Project	Oberon Sports Facility- 31 O'Connell Road, Oberon
Report	BCA Assessment Report (BCA 2022)
Reference	240021-BCA Report-r1
Date	9/02/2024
Client	Crossmuller Levi Yates 124 Lowes Mount Road Oberon NSW 2787
Email	<a href="mailto:yatesl@crossmuller.com.au">yatesl@crossmuller.com.au</a>

Reference/Revision	Date	BCA Assessment Report
240021-BCA Report-r1 Draft DA report issued for review	09/02/2023	Prepared by Adam Southwell Building Surveyor – Unrestricted (A1) BDC 3305

Figure | Image of the proposed development | source: Space Urban architectural plans

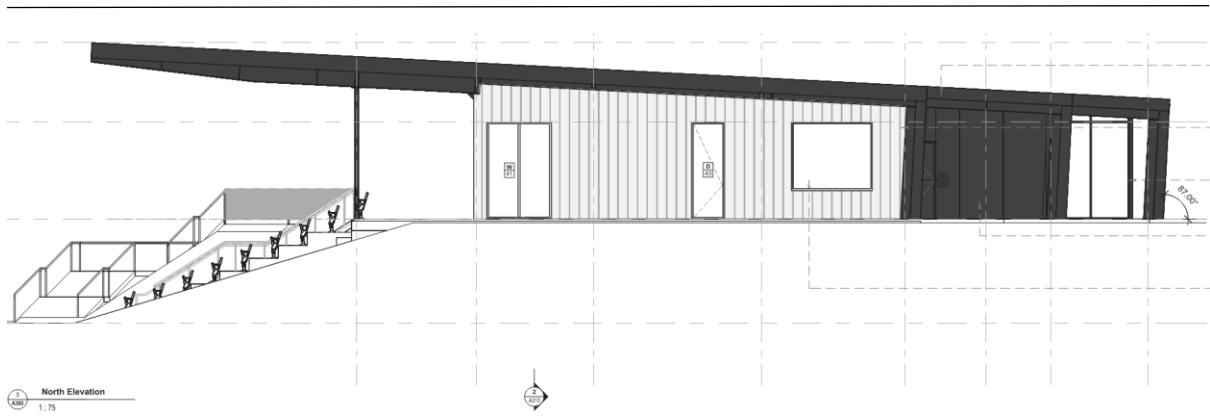
Item	Amendments required	DtS Provision
1.	There is currently a shortfall of 4 closet pans for female patrons.	F4D4
